PREST • VUKSIC
ARCHITECTS

June 5, 2014

SUBJECT: PRELIMINARY REVIEW 2014-071: LA QUINTA SQUARE

LA QUINTA COMMERCIAL CENTER

EXHIBIT 8

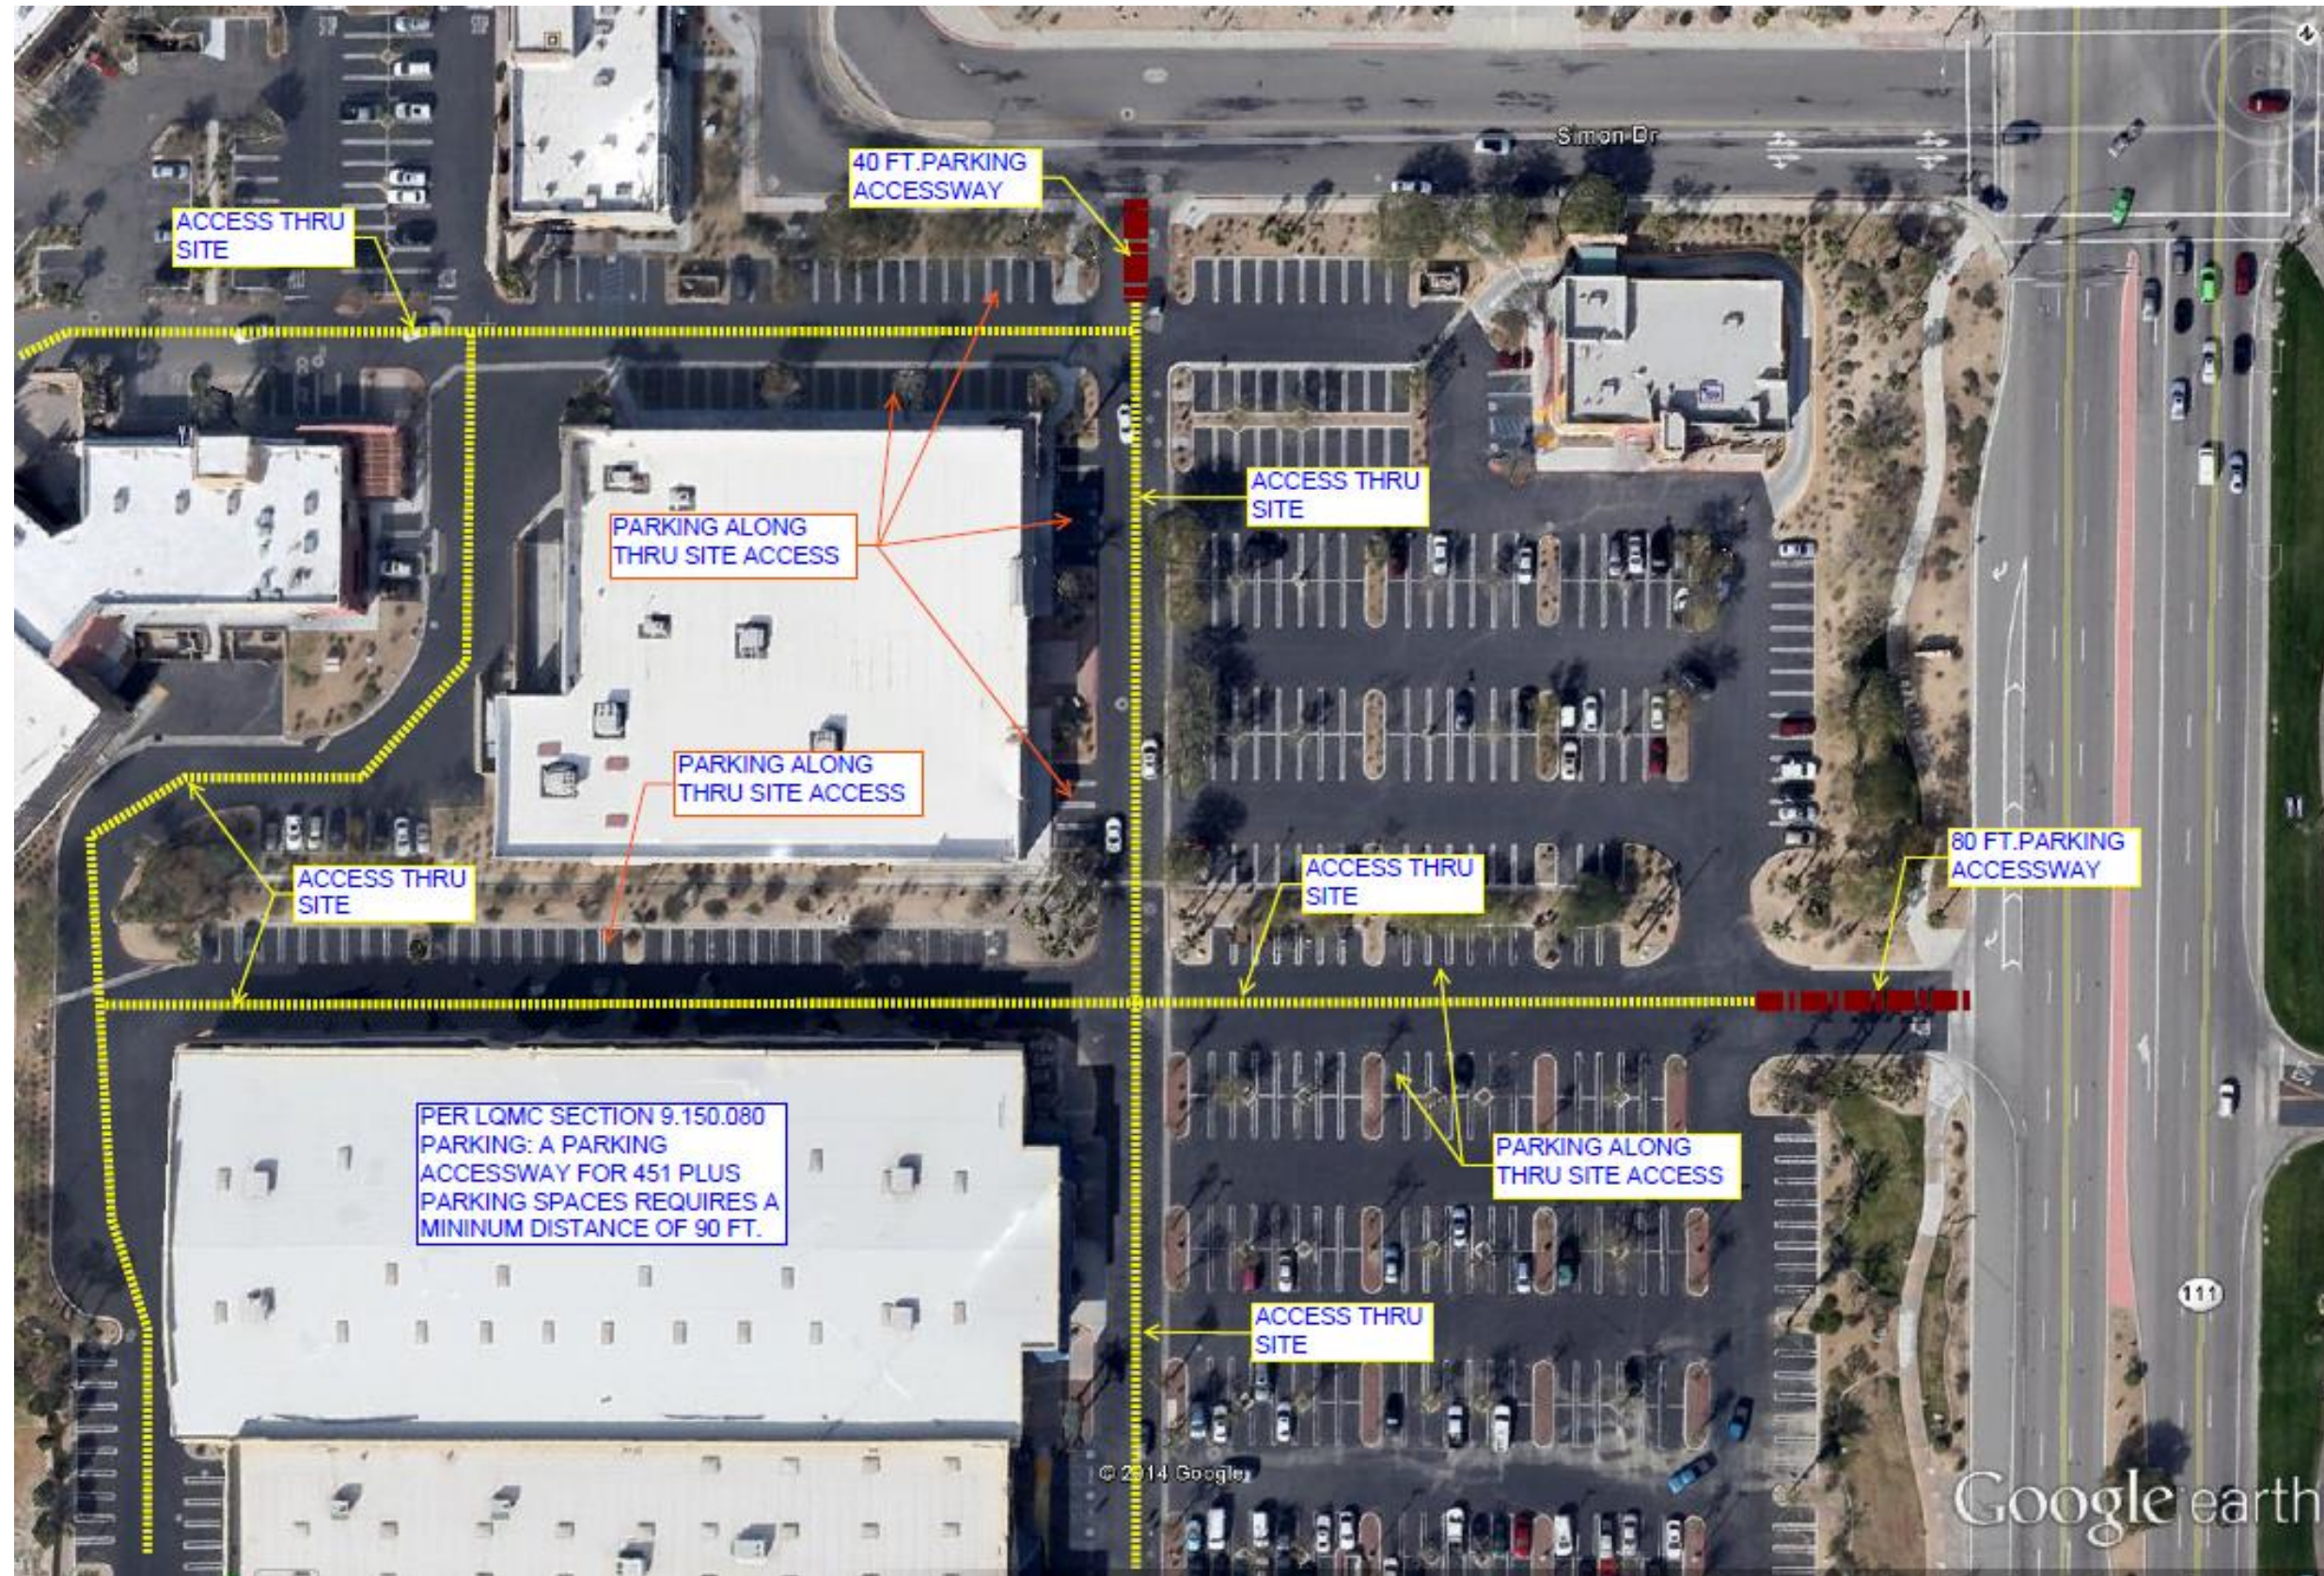
- Please consider the incorporation of one or more driveway and/or pedestrian connections to the existing commercial development to the west.

1. Please refer to Google Earth aerial to view both properties and to understand the comments provided herein. Please refer also to the site plan. (See Exhibit 8 for reference). Direct pedestrian access between sites is limited to the NE building. The building just south (that houses the restaurant) of the NE building does not have a sidewalk along the north and east side which is back of house. To reach the connection point between the two properties, from the restaurant building a person would travel to the NW corner of the restaurant building to a pedestrian sidewalk that is west of the restaurant building. This pedestrian sidewalk runs north past the NE building's west side to 111. The most prominent route would be to continue to the 111 parkway's meandering sidewalk which travels east to La Quinta Square. The rest of this development's building links to the north and west side of this project's beautiful parkway with meandering sidewalks. The west meandering sidewalk travels north and south along Washington to Trader Joe's, AAA and other retail stores. The north meandering sidewalk travels west to east along Hwy 111 which will take one to La Quinta Square, Beer Hunter and other retail stores. A pedestrian pass-through into La Quinta Square would at the west wall by the NE building would be seldom used in our opinion. The expense for the pedestrian pass-through would not prove to be beneficial to either of the property owners or the applicant.

The architects and owner/developer have considered the incorporation of a driveway and/or pedestrian connection to the existing commercial development to the west with the following conclusions:

EXHIBIT 8

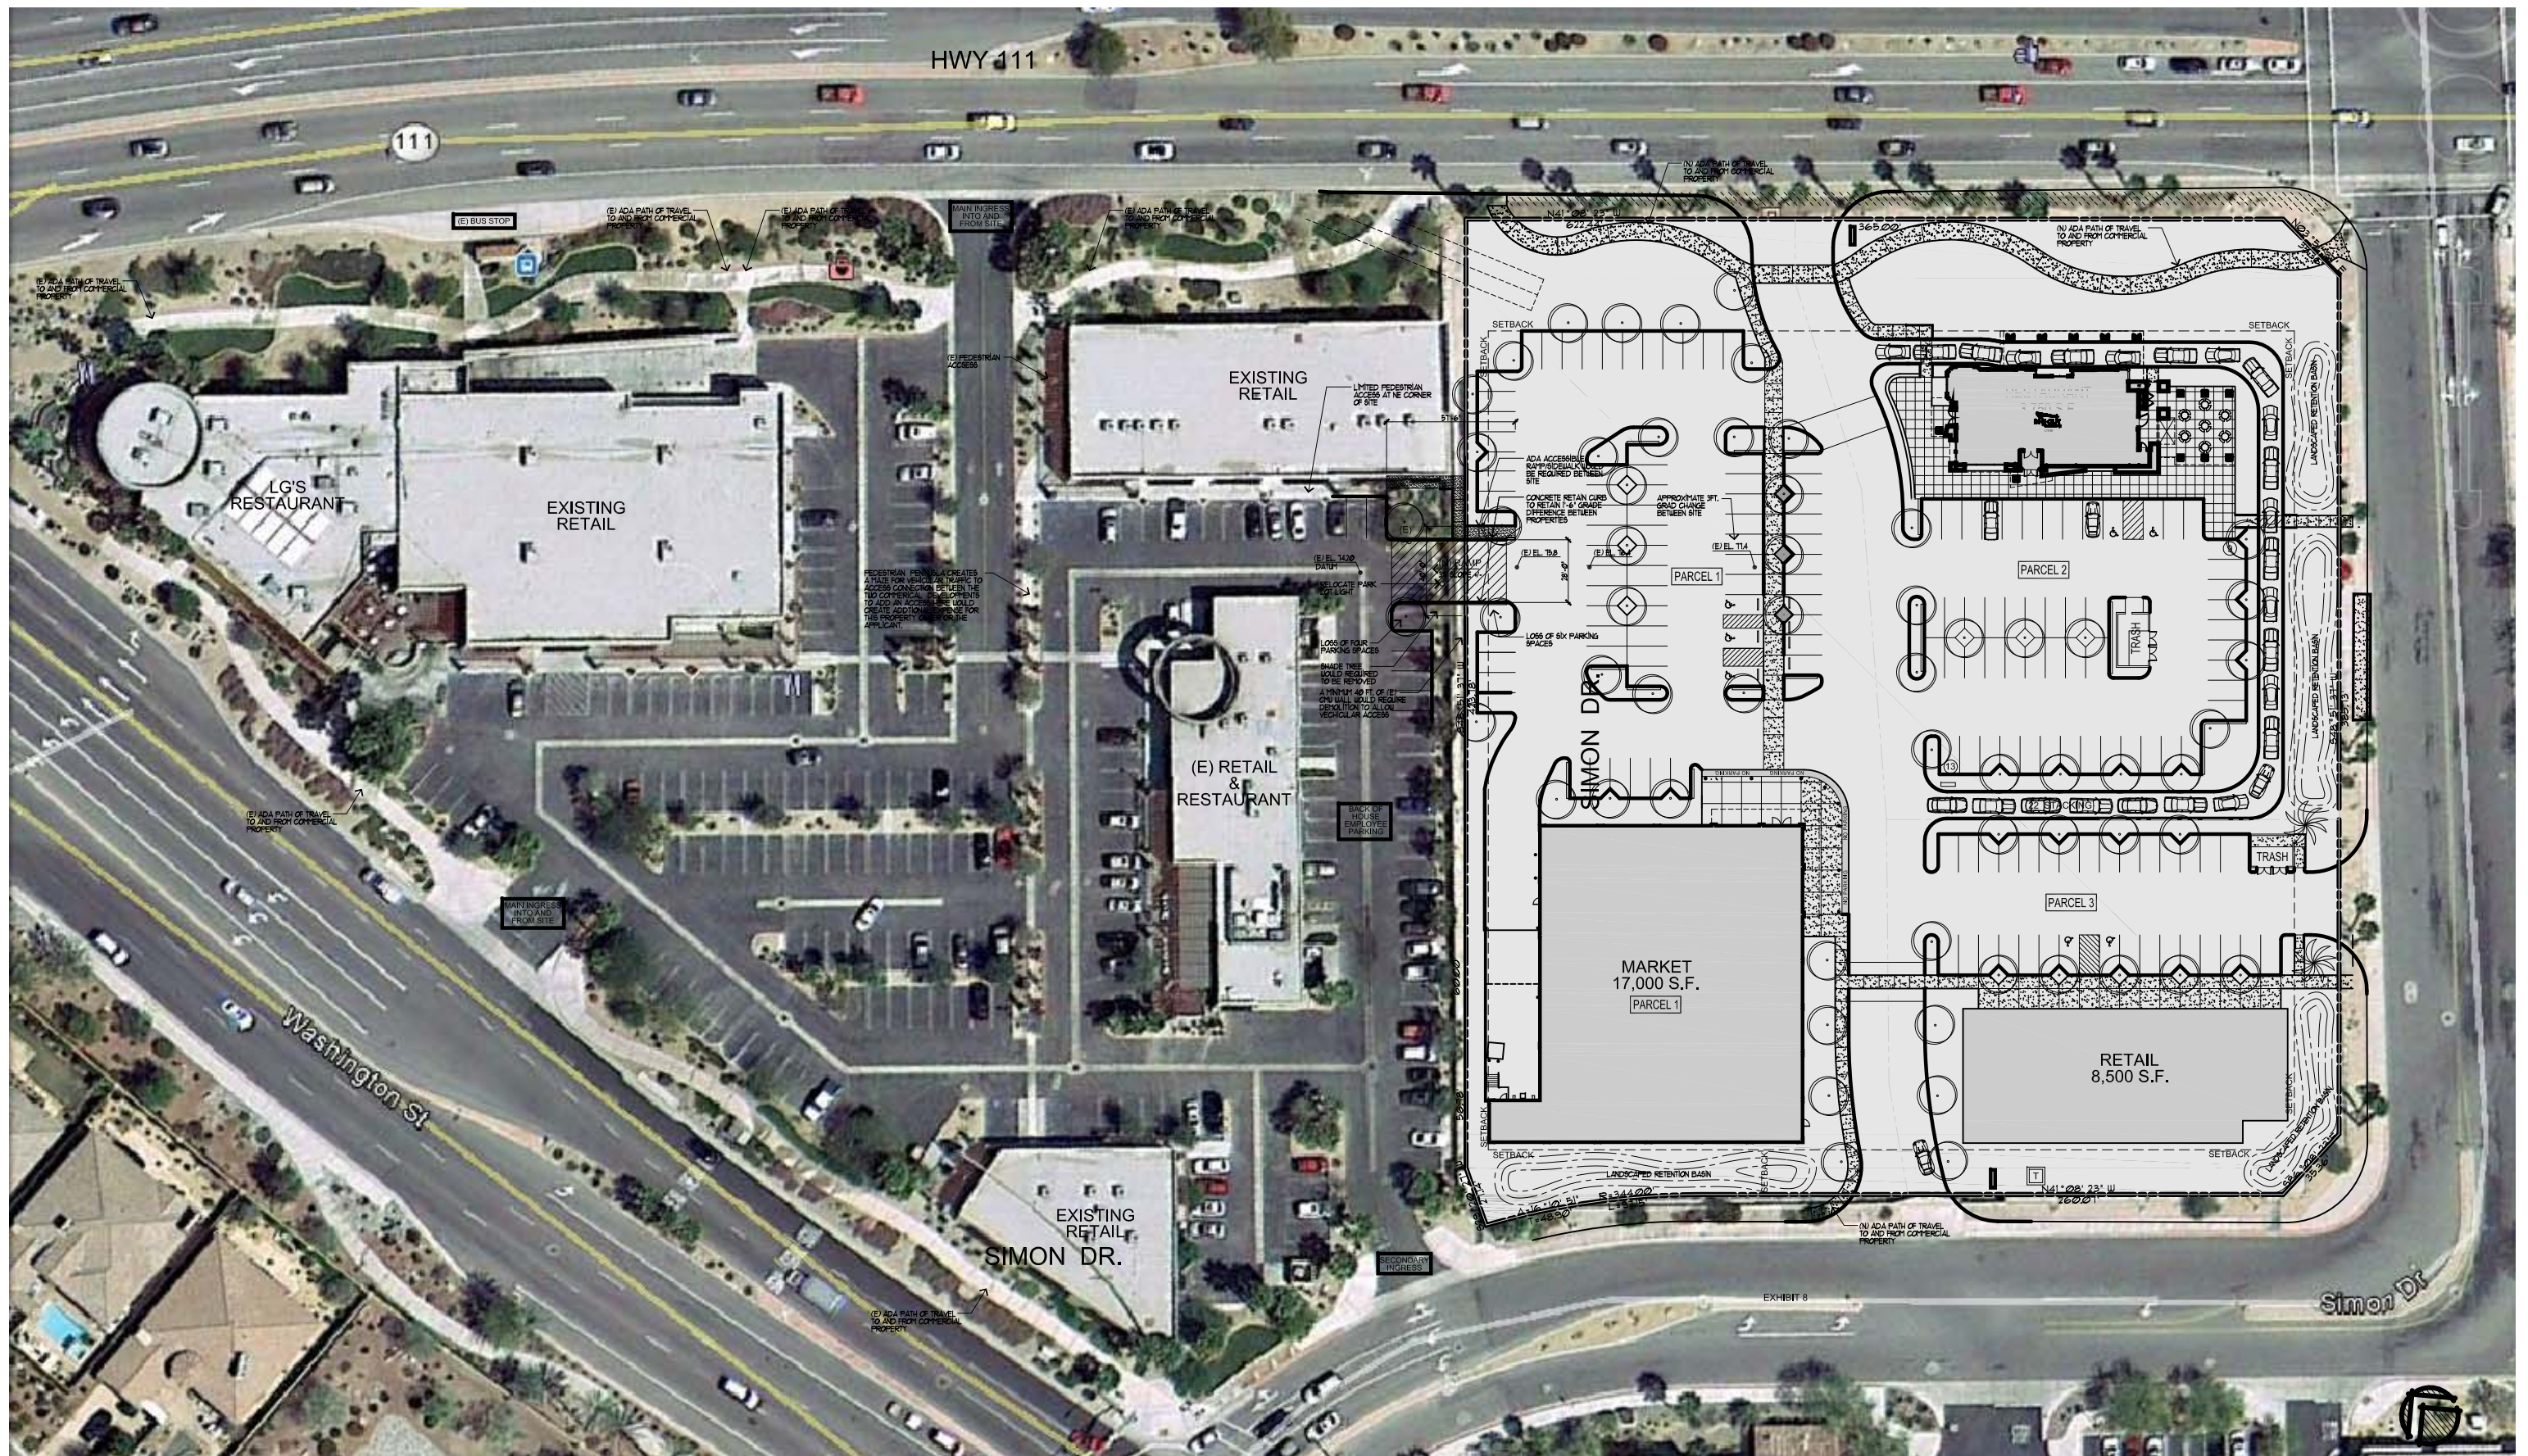
an accessible path of travel links the two sites at the NE building, then the code requires that both sites will have to be fully accessible throughout the site to each building. Question: Is the west neighboring commercial property fully ADA accessible and compliant or will it need to be brought up to code? Who pays for this the expenses to first find out and secondly the cost to bring the west neighboring commercial property up to code? As pointed out in item #1, the sidewalks along Hwy 111 and Washington are already ADA compliant. (See Exhibit 8 for reference)

3. Vehicular access could only happen at one location due to existing conditions and La Quinta Square's site layout of the Market. This would happen at the neighboring property's drive aisle that runs west to east just south of the NE building. There is an approximately 18 inch grade difference (from end of ramp to end of ramp) between La Quinta Square and the neighboring property. A minimum 40ft of perimeter CMU wall would require removal to allow access and a ramped driveway with concrete retaining curbs at each side would be needed to connect the two properties. Looking at the existing vehicular circulation of the existing development using Google Earth, it would only benefit the NW building and possibly the restaurant. The easiest access for the rest of the neighboring property would be to leave the site and head east on Highway 111 to La Quinta Square. The cost of removing 40ft of perimeter retaining wall and adding retaining curbs and the new ramp driveway just for the NW building would not, in PVA's opinion, prove to be a substantial benefit to either the neighboring property owner or applicant. of the property owners or the applicant. (See Exhibit 8 for reference)

4. If the access between the two properties is installed this would result in the loss of at least 4 parking spaces on the neighboring property and the loss of 6 parking spaces at La Quinta Square due to stall alignment. (See Exhibit 8 for reference)

5. A parking lot pole light on the neighboring property would have to be relocated due to being in the new access ramp. This would create an additional expense for the neighboring property owner or applicant. (See Exhibit 8 for reference)

6. An existing mature shade tree would have to be removed. This would create an additional expense for the neighboring property owner or applicant. (See Exhibit 8 for reference)
